Highway Development Control Consultation Response

Planning Application Ref : Outline Permission – All matters Reserved for residential development for up to 175 dwellings

Description /Location : Land South of Coate Road , Devizes

Date of response : 20/05/2026

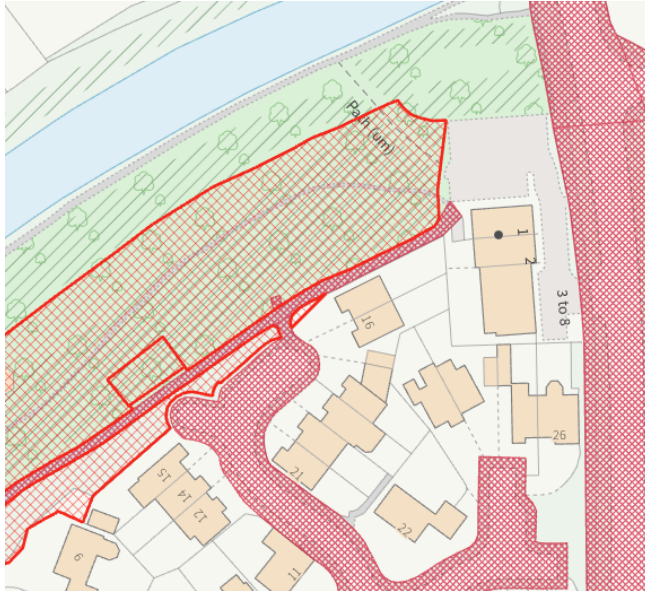
The Transport Assessment recognises that a connection to the canal via the Northern site is imperative. The Masterplan appears to show a link in a central location of both sites, however, there is no established route on the northern side. The applicant is welcome to discuss a new link with the owner to create a central link but if this does not come forward there should be a designed connection through to the emergency access /path to the eastern corner that allows for eventual access to the canal at the north/east corner of the site. The northern site also converts part of the Old Coate Road to a 3m cycle path, it is noted that there is a direct connection from the southern site to this path. The northern site is also brining forward a pedestrian link at the western corner on Coate Road and a connection to this link is being indicated.

The applicant is proposing the introduction of a new footway from Navigation Road to the cul-de-sac entrance, and this is welcomed, however, I would like to see this widened to 3m and this length of 3m path to be mirrored on the western side of Windsor Drive. The applicant will be expected to bring this forward via construction of the path widening and not via a contribution. This will support the location of a new crossing (please see below),
